02-06-23 SWEETGREEN #AUS285 - AUSTIN, TX (MUELLER) CX, TAB, IAQ

Name : 5 - VRF BRANCH CONTROLLER **Status :** Submitted
Assigned Organization : National TAB **Asset :**
Requesting Organization : National TAB

VRF_BREAKER.jpeg

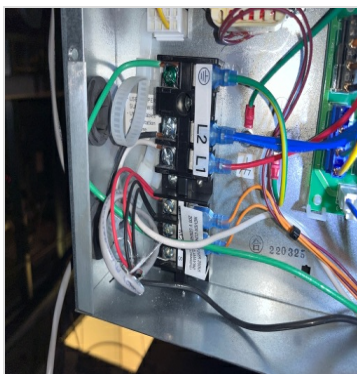
Circuit power MOCB breaker size, 15 amp has been installed

Yes

INSULATION.jpeg

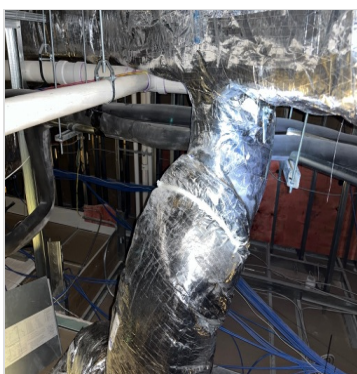
Line sets are fully insulated

Yes
